ADDENDUM NO. 2

October 31, 2024

PROJECT: FY24 LMIG & FY24 LRA LMIG for Roadway Resurfacing
W&A Project No.: W2009-061-01

OWNER: City of Tifton

Roadway Summary

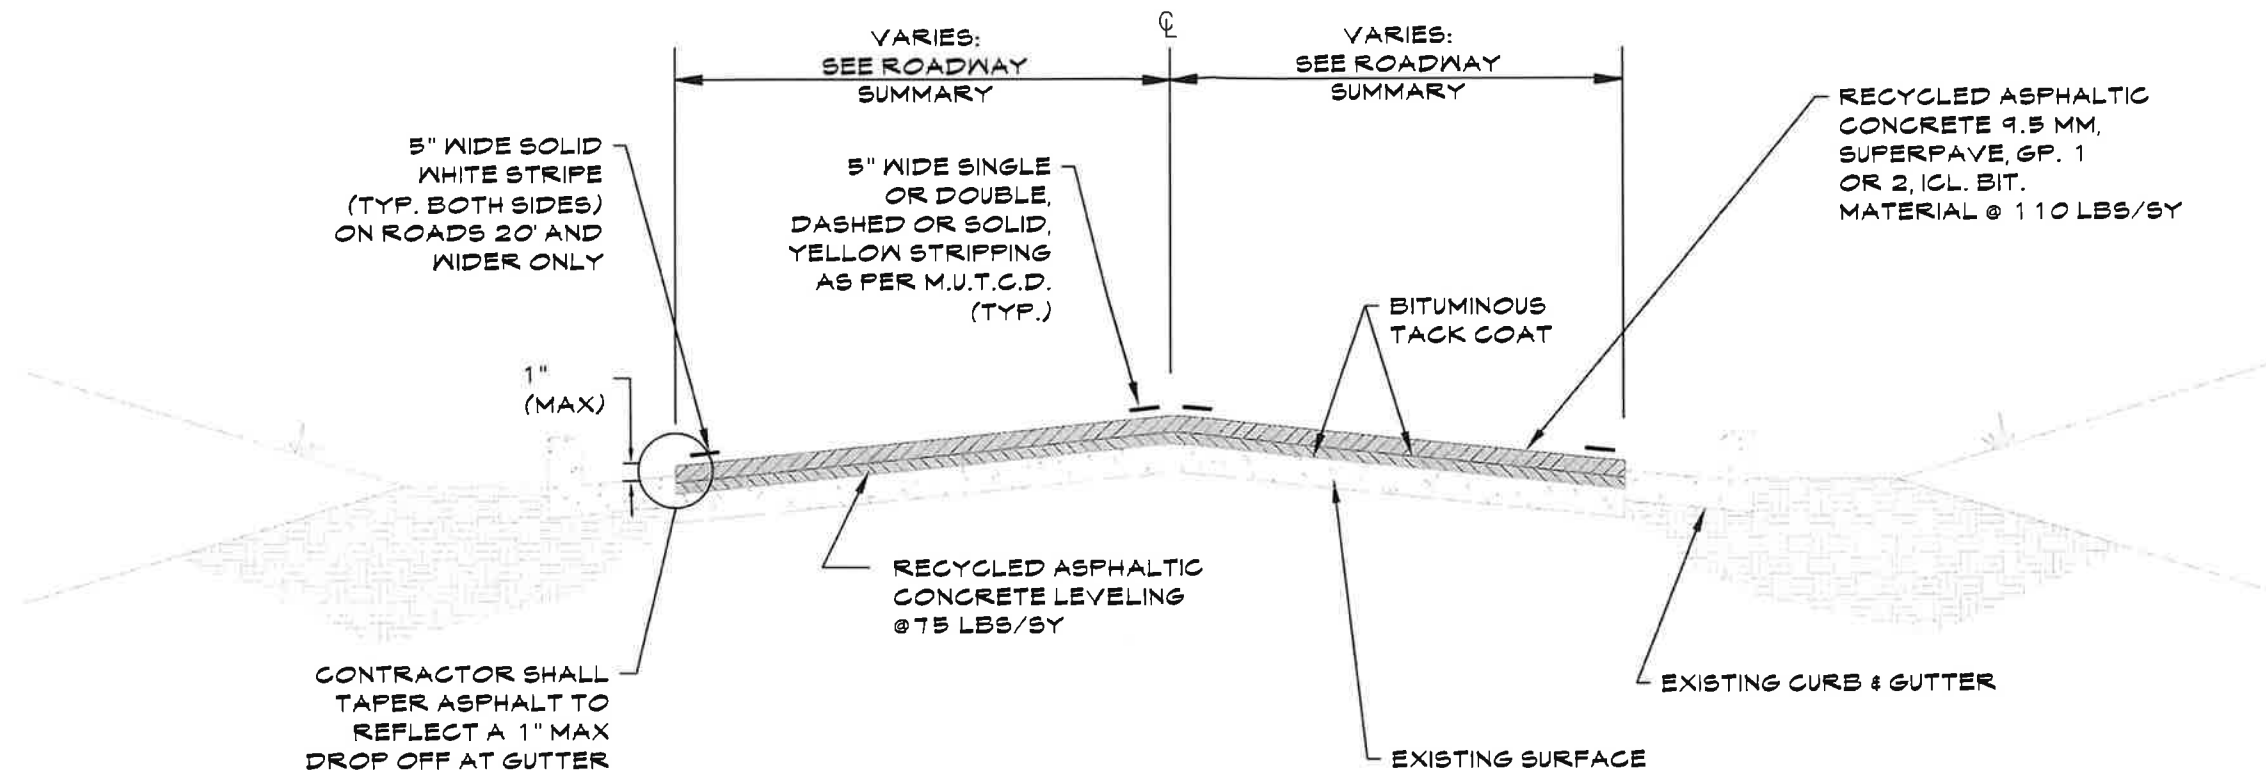
Appendix Item J (*Typical Section*) and Appendix Item N (*Roadway Summary*) have been revised. Please see attached.
